LOST CREEK I MASTER DEVELOPMENT PLAN

City of San Antonio
Development Services Department
Master Development Plan
REQUEST FOR REVIEW

The City Staff Development Review Committee has reviewed Lost Creek 1 Master Development Plan M.D.P. # 822. Please find enclosed a signed copy for your files. Your plan was accepted however please note the following:

TYPICAL STREET SECTION 60' ROW LOCAL TYPE 'B'
(NOT TO SCALE)

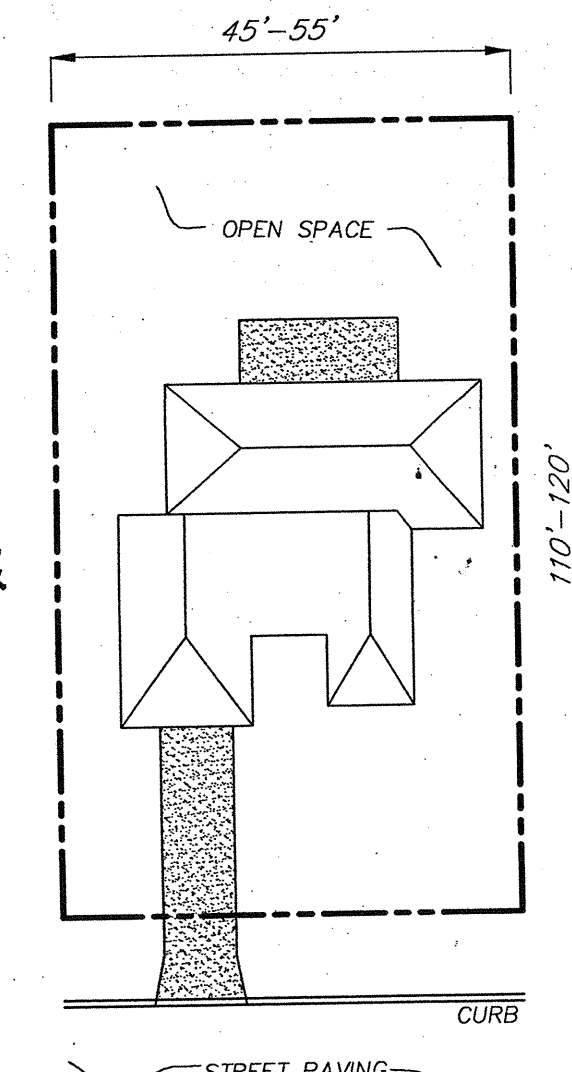
Comments: PROVIDE DIMENSIONS ON THE OLD FREDERICKS RD.
AS PER 35-B101(C) F(9)
PROVIDE DEDICATION ON OLD FRED RD. - REQUIRES 60 R.O.W
MAKE LOCAL "B" A COLLECTOR 70' R.O.W, AND LOCAL A'S, TIEING
IN LOCAL B'S 35-B101 APPENDIX A, STREET LOCAL "B" STREET COLLECTOR
AND 35-506(C)(1) CONVENTIONAL ST. CLASSIFICATION, TABLE 501
PROVIDE TWO POINT IDENTIFIED, BY TEXAS PLANNING COORDINATES
35-B101(C) E(1)

**Provide projection of street from unit-3 to undeveloped property, UDC 35-506(e)(2) projecting streets. Old Fredericksburg Rd. should have a min. of 60' ROW, provide dedication at the 55' min. section. 35-506(c)(1) Conventional Classification System
Table 506-1 and Appendix A: Street, Local Type "B"
Redline will Follow.**

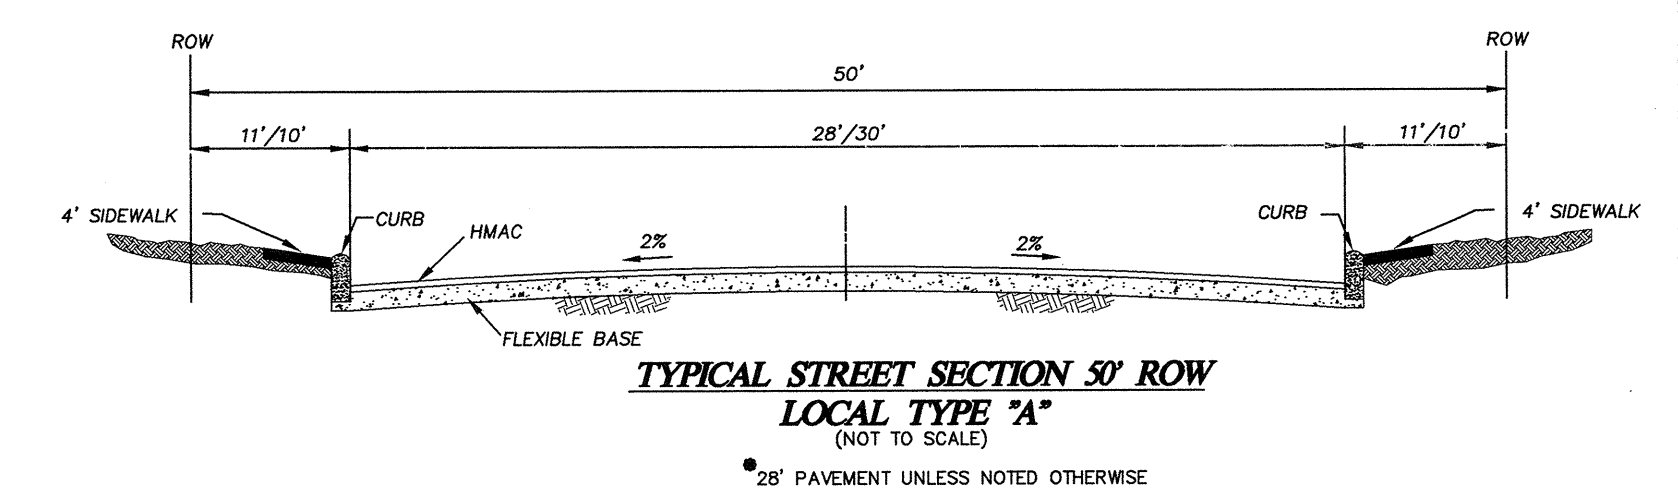
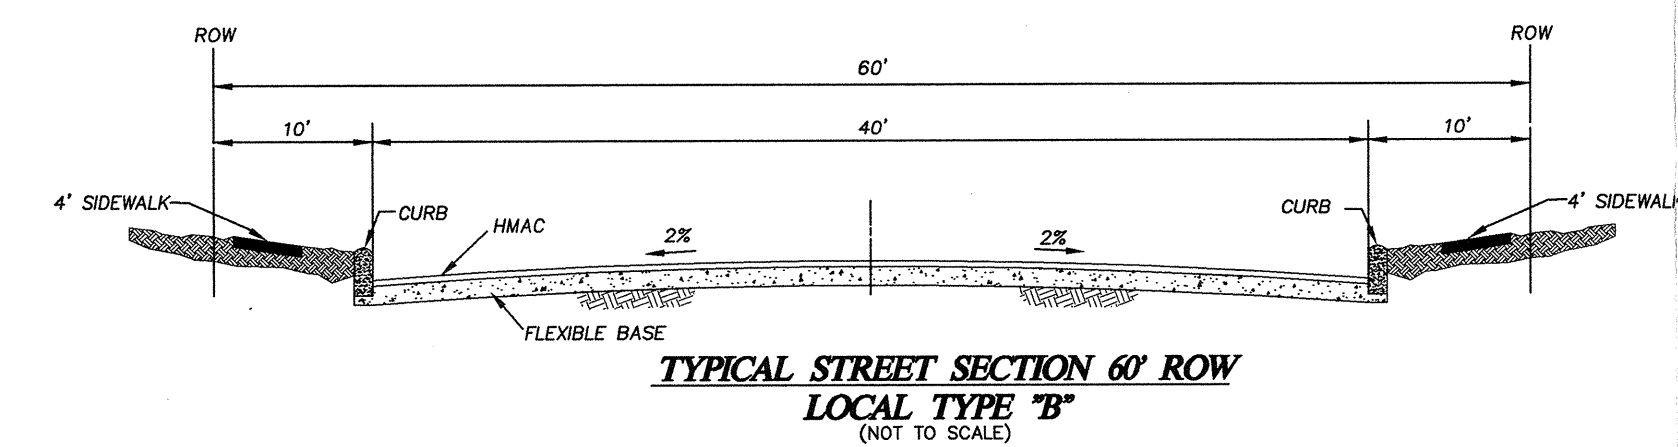
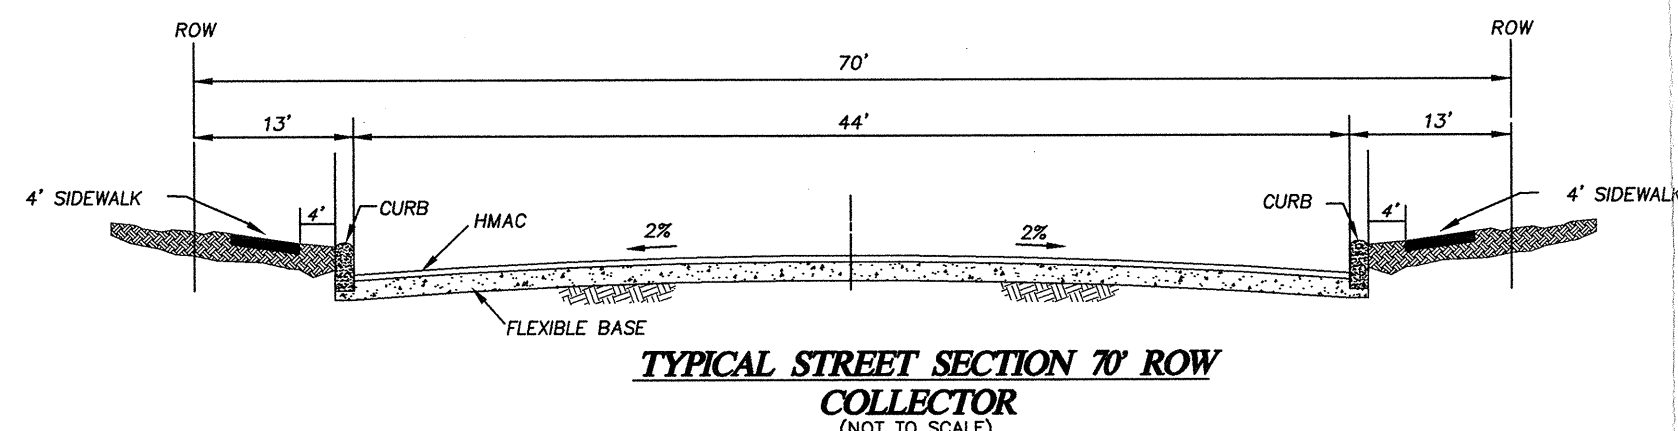
Include Flood Plain in Limits of MDP

Require Access to Street as per MDP
